**SERVICE
BULLETIN**

MANDATORY BULLETIN Z 242L/11a

Z 142C/ 7a

1. **AFFECTED AIRCRAFT :** Z 242L aircraft S/N 541, 651-659
Z 142C aircraft S/N 556-559
2. **SUBJECT :** At the extreme deflection of the nose-wheel steering the screw of the Spring-mechanism L 242.4217 may interfere with the nose-wheel strut body.

Fig.1

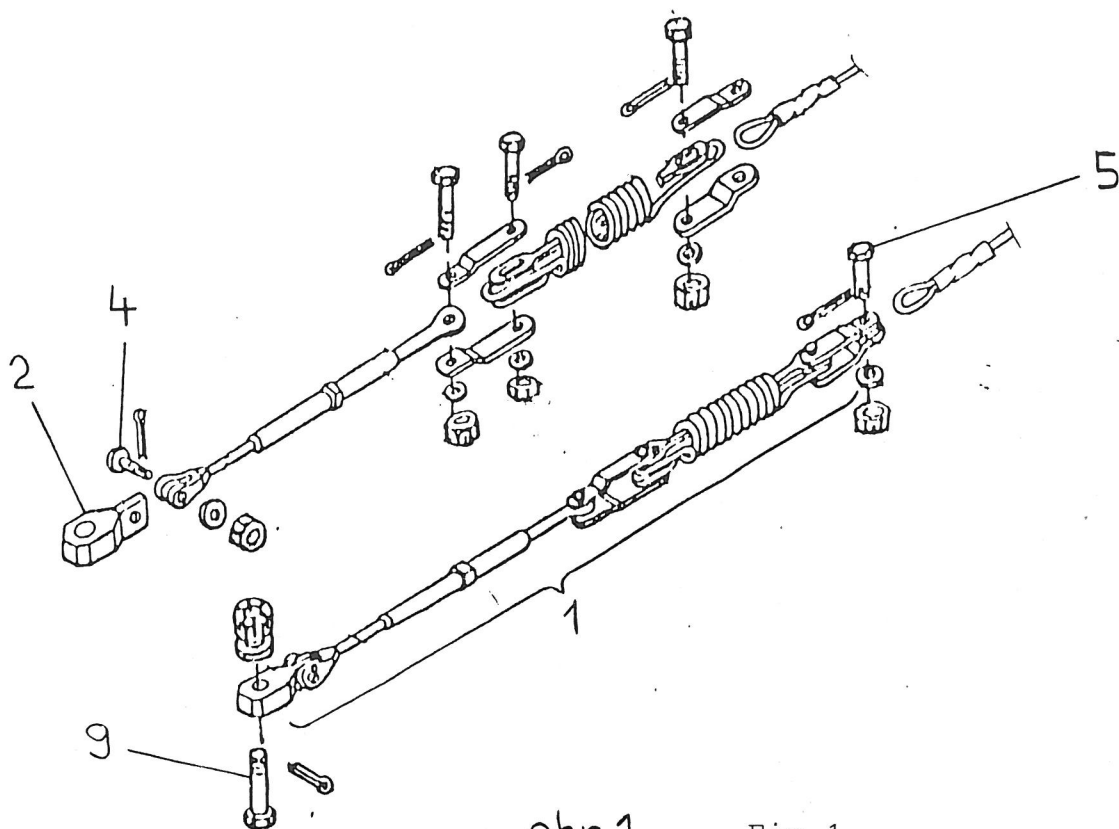
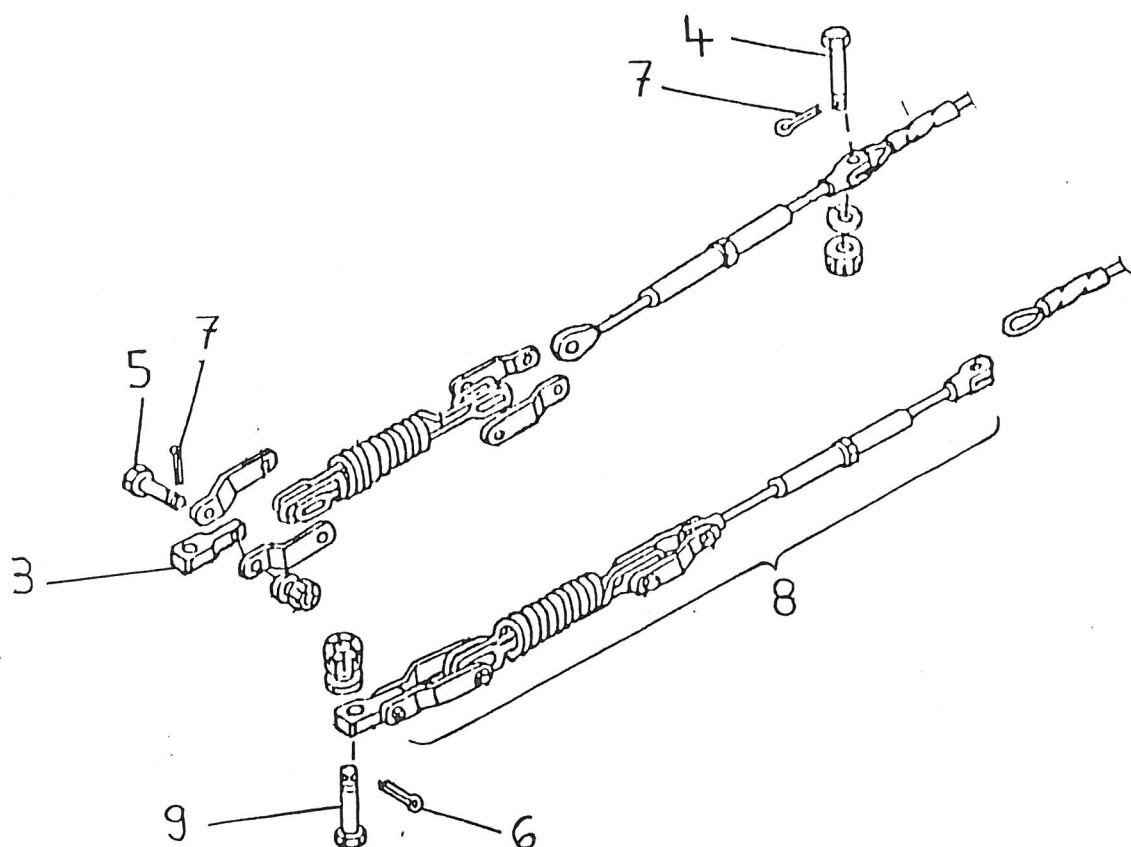
3. **CORRECTION :** Replace the cube Z 42.4217-00.03 by the cube L 242.4237-00.03 in the spring mechanism. Install the spring mechanism with its turnbuckle backwards.

- the Operator.
The material - the Manufacturer.
7. **PROCEDURE :**
 - a) Release the turnbuckle, remove the spring mechanism L 242.4217 (Item 1).
 - b) Remove the cube Z 42.4217-00.03 (Item 2).

- c) Install the cube (Item 3) between the shaped sheets (use the screw M5x16-Item 5, the new cotter pin - Item 7 from the delivered material).
 - d) Re-install the spring mechanism L 242.4237 (Item 8) (for attachment to the control cable use the screw M5x18 (Item 4), the new cotter pin /Item 7/); for attachment to the nose landing gear strut use the original screw (Item 9), the new cotter pin (Item 6) from the delivered material). Tighten the cube (Item 3) with the screw (Item 9), so that the cube moves on the screw (Item 9).

- e) Prestress the spring with the turnbuckle so that gaps between the spring coils 0,3-0,5 mm appear; then lock the turnbuckle with the binding wire. The rudder must be in the neutral position and the nose wheel parallel to the aircraft longitudinal axis during spring prestress adjustment.

- f) Check the nose wheel deflections and the control for easy movement.
- g) Replace old pages in the Z 142C Catalogue of Spare Parts by the new ones, enclosed to this Bulletin.
